TECHNCIAL NOTE no.: 55

Product:	Engine Fan Support
Part number:	5FR121207B
To:	Cupra Leon VZ TCR
Date:	28/05/2024

CUPRA **LEON VZ TCR** gearbox radiator position

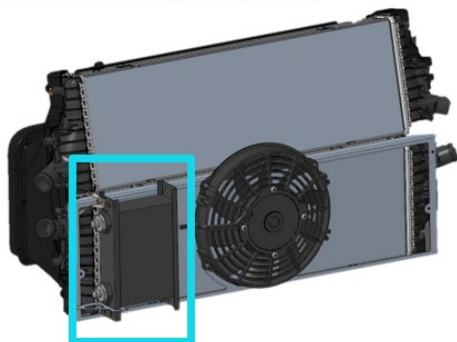
We have received reports of a radiator breakage after a frontal crash of a car model CUPRA LEON VZ TCR. It is always difficult to assess how serious the impact was in relation to the damages caused.

1. Customers to remove the old gearbox radiator supports (**in green**) in all existing CUPRA LEON VZ TCR cars. The lower one is the critical one.

2. CUPRA to modify the design. Soon we'll announce the availability of a renewed engine fan support. This new one, will be suitable for all cars models.
